6.1 1 & 7 WATERFRONT PLACE, PORT MELBOURNE

LOCATION/ADDRESS: 1 & 7 WATERFRONT PLACE, PORT MELBOURNE

PREPARED BY: JOCK FARROW, PRINCIPAL PLANNER

1. PURPOSE

Figure 4: Proposed ground floor

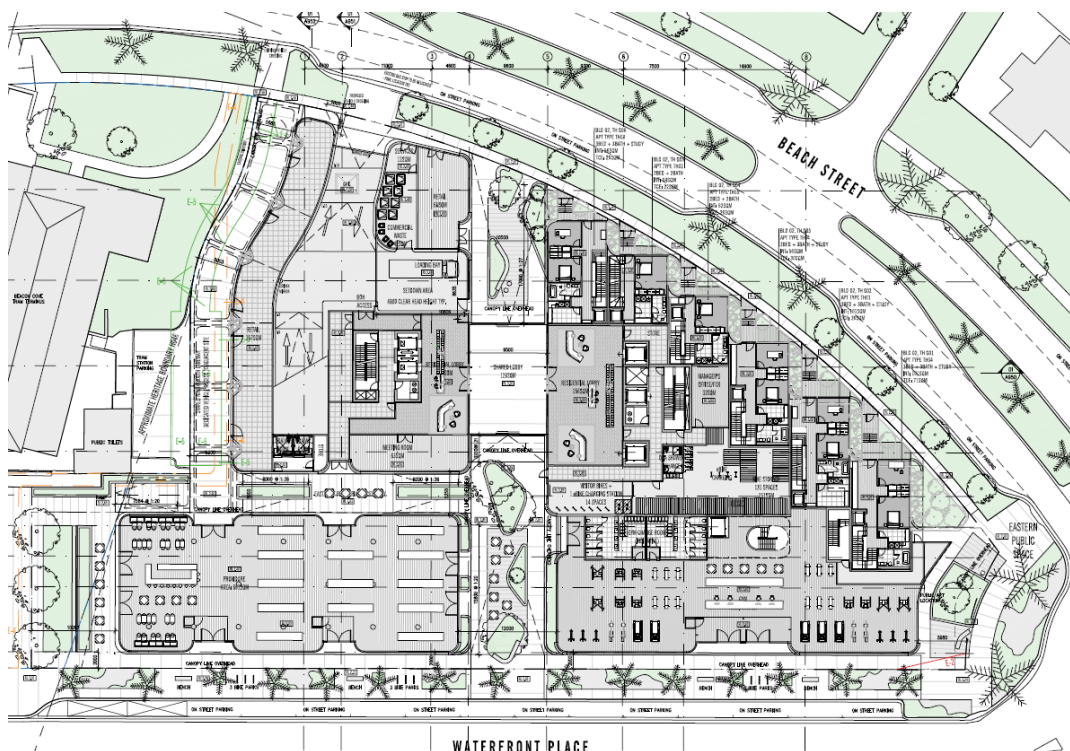
Access to the Gym, Provedore and Cafe include large internal landings and steps, with platform lifts also shown on plans. Given the small height difference, a short ramp would provide more equitable and dignified access than a platform lift. Ramps are also less expensive to both install and maintain, are quicker for people to use, and more reliable because they never break down.

The Gym floor level and/or doorway locations could be further improved to provide level access from at least one frontage i.e. current layout requires steps *up* from the street but steps *down* from the central laneway.

- d) Public seating provided to the eastern 'parklet'.
- e) Internal disabled ramp access to the southern entrances of the food and drink premises, provedore and gym. Ramp access can replace platform lifts.

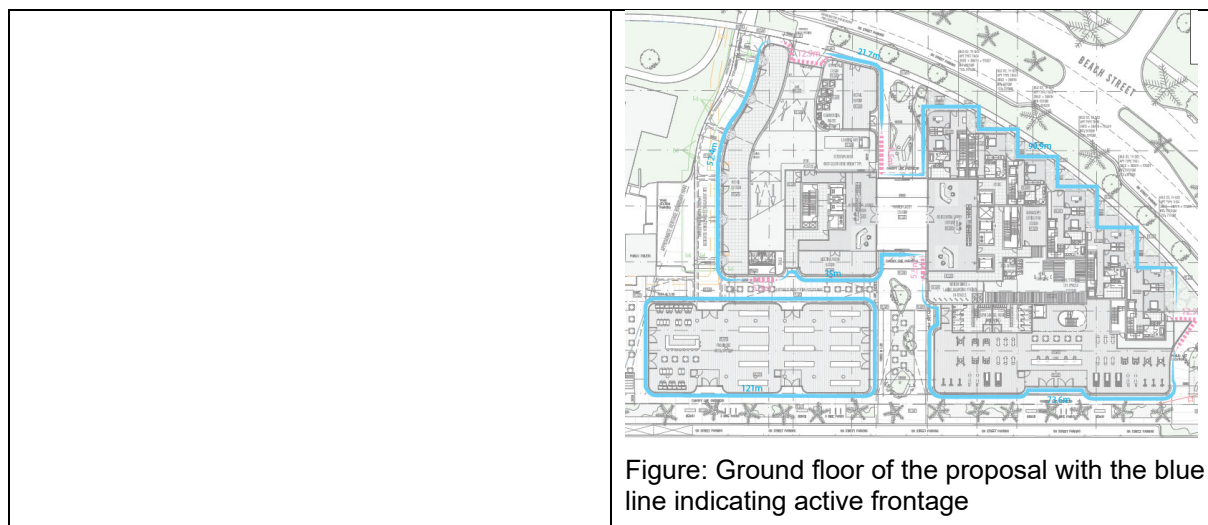
<p>Building frontages to Waterfront Place must be set back 2m from the property boundary, to allow for widening of the footpath. (Mandatory)</p>	<p>Satisfied subject to condition: The building frontage to Waterfront Place would be setback 2m from the southern boundary.</p> <p>However, architectural corner features would encroach slightly into the requirement as would a planter associated with the central/southern public open space. Should a permit issue, a condition will require all buildings at ground floor to be setback 2m from the southern boundary, including the architectural corner features and the planter.</p> <p>This requirement interrelates with design requirement D4 which allows balconies to extend beyond the building line provided the ground floor is setback 2m; as such, the mandatory component of the requirement relates to the ground level setback.</p>
<p>Buildings located at the western boundary of the site must provide for a ground level east-west pedestrian access way that creates a visual connection between the tram stop, the central courtyard space and the north/south pedestrian laneway. (Mandatory)</p>	<p>Satisfied: An east-west pedestrian link would be provided in accordance with the requirement.</p> <p>This requirement interrelates with the final design requirement of A1 which requires, amongst other things, 24 hour public access to the link and for the link to be 5m wide.</p>

<p>Pedestrian linkages through the site must be designed so as to provide unrestricted access to the public on a 24-hour basis. They should be straight and direct, providing a clear line of sight through the walkways and must be a minimum of 5m in width. (Mandatory)</p>	<p>Satisfied: For the avoidance of doubt, it is highlighted that while the requirement in its entirety is 'mandatory', there is an element of judgment required to ascertain compliance with the second criteria, by reason of the usage of 'should' i.e. <i>They should be straight and direct, providing a clear line of sight through the walkways and must be a minimum of 5m in width.</i></p> <p>It is also important to understand what a 'pedestrian linkage' is in the context of the controls; the relevant pedestrian linkages are the north/south laneway along the western boundary of the site; and, the east/west linkage that is required to link the aforementioned laneway with the central courtyard space. There is no requirement for the two areas of open space (northern courtyard and central/southern courtyard) to be connected.</p> <p>With regard to the first criteria, the 'pedestrian linkages' are designed so as to provide unrestricted access to the public on a 24-hour basis.</p> <p>With regard to the second criteria, the east/west linkage is straight and direct, providing a clear line of sight through the walkway and achieves a minimum width of 5m. However, it is noted that</p>

<p>this link is an underpass, having no views to the sky; as such, there would be little to no benefit from having planter boxes and seating in this area, they would simply disrupt pedestrian and loading movements. A condition on any permit would require the removal of the seating and planter boxes within the east/west pedestrian linkage.</p> <p>With regard to the north/south laneway, this would provide a 'direct' link based on origin and destination rather than a straight line, it would achieve a minimum width of 5m along with a clear line of sight through the laneway from all key vantage points i.e. from the northwest corner of the food and drink premises, views along the full length (both directions) of the laneway would be achieved; from the northern entrance of the food and drink/providore, views would be available for the northern extent of the laneway and also easterly, through the east/west linkage. Furthermore, an alternate route would effectively see the laneway continued through the building, providing a direct sightline through the glass façade. The angled building overhang (over the alfresco area) would contribute to appropriate way finding to the pedestrian link; it would also be discoverable from the north, from the tram terminus along with anyone entering the Site from the south (whether from the east/west linkage or directly).</p> <p>Overall, the design response is considered to be acceptable and in compliance with the mandatory requirements.</p>

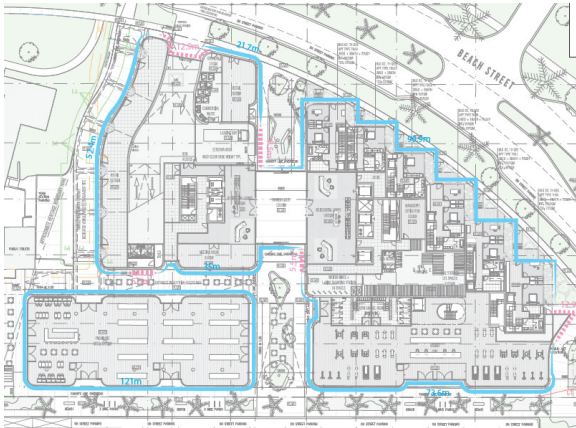
<p>B2: Tower height, siting and massing</p>	<p>Assessment:</p>
<p>Development must not exceed a maximum height of 10 storeys and 35 metres (inclusive of the podium and exclusive of rooftop services).</p> <p>(Mandatory)</p>	<p>Satisfied subject to condition: The proposal generally complies with the mandatory building height of 10 storeys and 35 metres, exclusive of rooftop services.</p> <p>However, included within the 'roof top services' are rooms (roofed and enclosed) upon the roof level. While the intention of these rooms may be to house services, they are nonetheless considered a storey in their own right. As such, the rooms will need to be removed to ensure the development does not breach the 10 storey height limit, it is recommended this be required by condition.</p> <p>With regard to rooftop services, the following exemption at section 2.0 of the DDO is relevant:</p> <p><i>A permit cannot be granted for buildings and works exceeding the maximum height specified in this Schedule other than:</i></p> <p><i>Architectural features such as building services may exceed the maximum height by up to 4 metres providing they do not exceed 10% of the gross floor area of the top building level.</i></p>

<p>Based on the above exemption, the western tower has an allowable services area of 53.3sqm while the eastern tower has an allowable area of 33sqm.</p> <p>The eastern tower meets the exemption. However, the western tower would exceed the allowable area, with services equating to approximately 89sqm.</p> <p>A recommended condition would require it to be demonstrated that architectural features, such as building services, that exceed the maximum building height, do not exceed the height by more than 4 metres and do not exceed 10% of the gross floor area of the top building level.</p>
<p>Development above 3 storeys (and 12 metres) must be set back a minimum of 8 metres in addition to any ground level setback.</p> <p>(Mandatory)</p>	<p>Satisfied subject to conditions: The height component of this requirement coincides with the mandatory height limit of the podium level, as prescribed by requirement B1. It effectively requires the tower elements to be setback 8m from the ground floor setback.</p> <p>The applicant has indicated the required 8m setback with a red outline, with the intention being that the tower levels are entirely sited with the red line envelope. The majority of the tower interfaces (including architectural features which project from the façades) comply with the requirement.</p> <p>However, to the eastern corner of the development, the tower setback appears to be mistakenly measured from property boundary as opposed to the ground level setback. This results in the lower levels of the tower at this location encroaching into the setback requirement by approximately 1m.</p> <p>In addition to the above, it is evident that canopies along the southern tower elevations and to the eastern corner extend beyond the aforementioned red outline.</p> <p>It is recommended to include a condition which would require all setbacks to be in compliance with the requirement.</p> <p>With regard to the balustrades (associated with the terraces/balconies) upon the podium level, these elements of development benefit from the exemption at design requirement D4, which states <i>Balconies may extend beyond the building line along the Waterfront Place frontage, if the ground floor is setback 2m from the site boundary.</i> The development would accommodate a 2m setback from Waterfront</p>

Place at ground floor, thus it benefits from the exemption.
The maximum height and siting of any tower form must be generally in accordance with Figure 1 of this Schedule.	Satisfied: The maximum height and siting of the towers are generally in accordance with Figure 1 of the Schedule (DDO23).
Any tower form should use design techniques to avoid a monolithic or bulky appearance. This should include separation into two tower forms with an average separation of 10 metres.	<p>Satisfied: The building would effectively be split in half by the two areas of public open space located centrally within the Site, this separation would carry through all upper levels resulting in a building/tower separation of approximately 9.6m.</p> <p>In addition to the building separation, a number of the other built form responses and design techniques would effectively focus the massing and minimise visual bulk. The sweeping curved facades would limit the overall building volume visible from any one vantage point. The tiered tower forms would result in more slender towers as height increases. The curved architectural features which rise vertically up the façades would both break up the façade and draw the eye upward, accentuating the vertical emphasis of the building and provide a visual cue to give the appearance of taller and more slender towers. The extensive use of glazing provides a 'lightness' to the upper levels.</p>
